# National Committee on Uniform Traffic Control Devices

Item No.: 20B-TTC-03

## NCUTCD Proposal for Changes to the Manual on Uniform Traffic Control Devices

Shoulder Work

Figure 6H-32. Half Road Closure on a Multi-Lane, High-Speed Highway (TA-32)

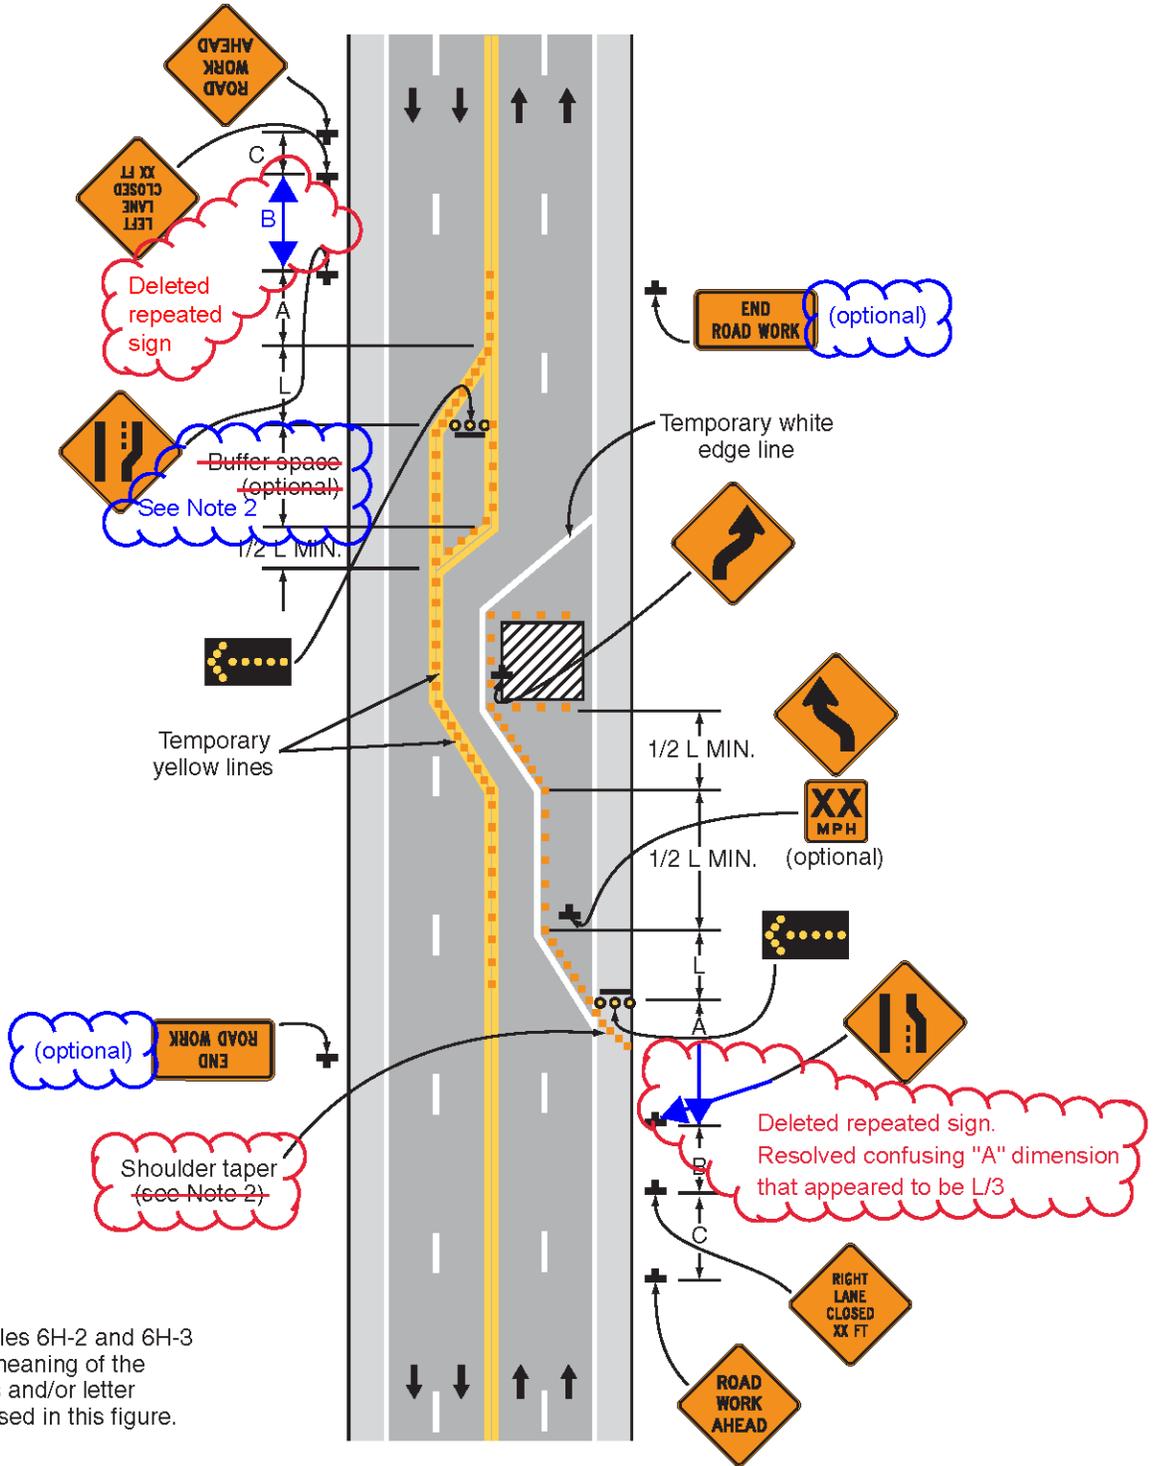
189 High-speed is proposed to be deleted from the typical application title. The typical application can be  
190 used for any multi-lane highway or road, not only a high-speed highway.

191  
192 In Typical Application 32 for a multi-lane highway, the use of a shoulder taper is necessary to delineate  
193 the arrow board, regardless of the shoulder width or whether it is paved or not. It is proposed that note 2  
194 be deleted and added to Section 6C.08 as P11a so the concepts are applicable to all typical applications.

196 A new standard, inserted as a new note 2, is proposed to address the arrow board placement and buffer  
197 space conflict shown at the top of Figure 6H-32. This concept crosses over with the concepts in 20B-  
198 TTC-01. See 20B-TTC-01 for further discussion.

199  
200 The RIGHT (LEFT) LANE CLOSED XX FT sign is repeated at the top and bottom of Figure 6H-32.  
201 For consistency with the three advance warning sign series in most typical applications, the repeated sign  
202 is proposed to be deleted. On the bottom right corner of the figure, the “A” dimension is proposed to be  
203 modified to make it clear that the sign spacing and the 1/3 L length of the shoulder taper are not the same  
204 distance. Deletion of old note 2 on the notes page necessitates the removal of “(see Note 2)” from the  
205 figure. The buffer space note is removed from the figure and a reference to new note 2 is added to  
206 correlate with the proposed changes to the notes. The text “(optional)” is added adjacent to the END  
207 ROAD WORK signs to be consistent with other typical applications.

1. For long-term stationary situations, conflicting Ppavement markings ~~no longer applicable~~ shall be removed or obliterated and temporary markings shall be provided as soon as practical. ~~Except for intermediate-term and short-term situations, temporary markings shall be provided to clearly delineate the temporary travel path.~~ For short-term stationary and intermediate-term stationary situations where it is not feasible to remove and restore pavement markings, closely spaced channelizing ~~ation~~ devices shall be used ~~made dominant by using a very close device spacing.~~
2. If an arrow board is used in the closed lane, the longitudinal distance downstream of the arrow board shall not be used as buffer space.

- ~~2. When paved shoulders having a width of 8 feet or more are closed, channelizing devices should be used to close the shoulder in advance of the merging taper to direct vehicular traffic to remain within the traveled way.~~
3. Where channelizing devices are used instead of pavement markings, the maximum spacing should be  $1/2 S$  feet where  $S$  is the speed in mph.
4. If the tangent distance along the temporary diversion is less than 600 feet, a Double Reverse Curve sign should be used instead of the first Reverse Curve sign, and the second Reverse Curve sign should be omitted.

Figure 6H-33. Stationary Lane Closure on a Divided Highway (TA-33)

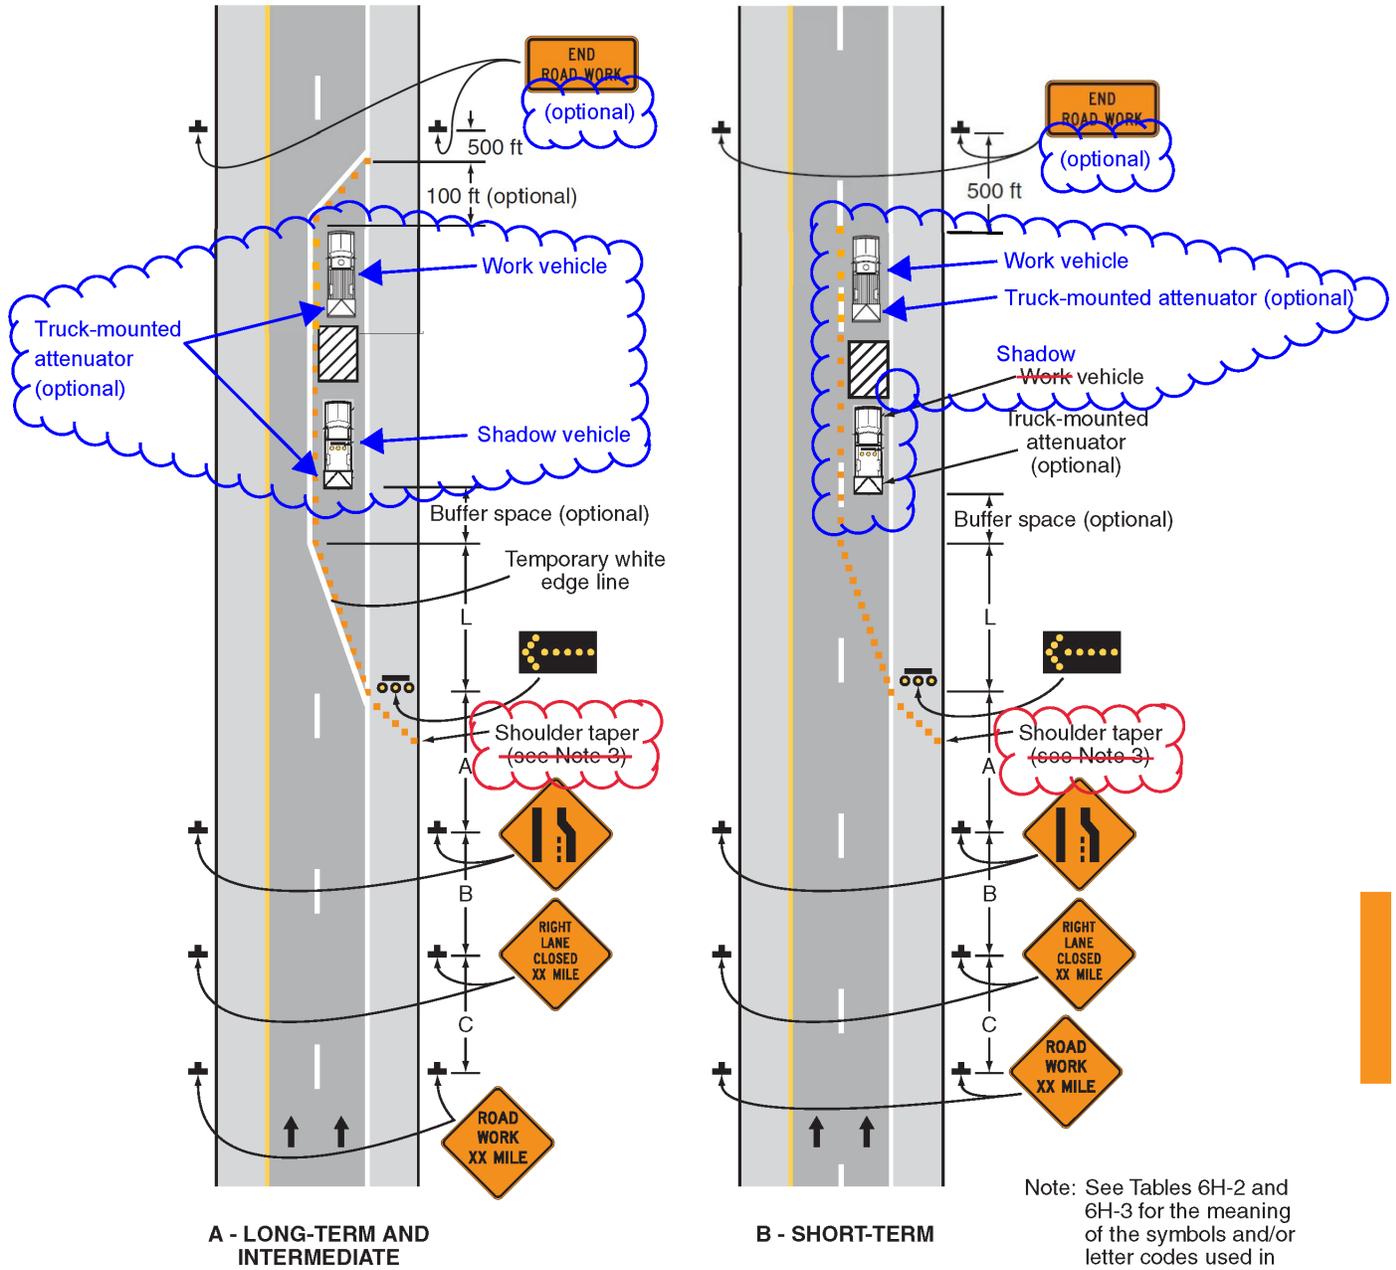
208  
209 *Typical Application 33*  
210 In Typical Application 33 for a divided highway, the use of a shoulder taper is necessary to delineate the  
211 arrow board, regardless of the shoulder width or whether it is paved or not. It is proposed that note 3 be  
212 deleted and added to Section 6C.08 as P11a so the concepts are applicable to all typical applications.

213  
214 A new standard, inserted as a new note 3, is proposed to be added to require that shadow and work  
215 vehicles display high-intensity rotating, flashing, oscillating, or strobe lights to be consistent with other  
216 typical applications.

217  
218 On Figure 6H-33, a work vehicle and shadow vehicle are added to A – long-term and intermediate. A  
219 shadow vehicle is added and the work vehicle moved in B – short-term to coordinate with TA-4 and the  
220 proposed revisions to TA-6. Deletion of old note 3 on the notes page necessitates the removal of “(see  
221 Note 3)” from the figure. The text “(optional)” is added adjacent to the END ROAD WORK signs to be  
222 consistent with other typical applications.

1. This information also shall be used when work is being performed in the lane adjacent to the median on a divided highway. In this case, the LEFT LANE CLOSED signs and the corresponding Lane Ends signs shall be substituted.
2. When a side road intersects the highway within the TTC zone, additional TTC devices shall be placed as needed.
3. Shadow and work vehicles shall display high-intensity rotating, flashing, oscillating, or strobe lights.

- ~~3. When paved shoulders having a width of 8 feet or more are closed, channelizing devices should be used to close the shoulder in advance of the merging taper to direct vehicular traffic to remain within the traveled way.~~

4. A truck-mounted attenuator may be used on the shadow vehicle or on a work vehicle ~~and/or the shadow vehicle.~~
5. Additional positive protection devices may be used per Section 6F.84a. [approved by Council 01/10/2020]
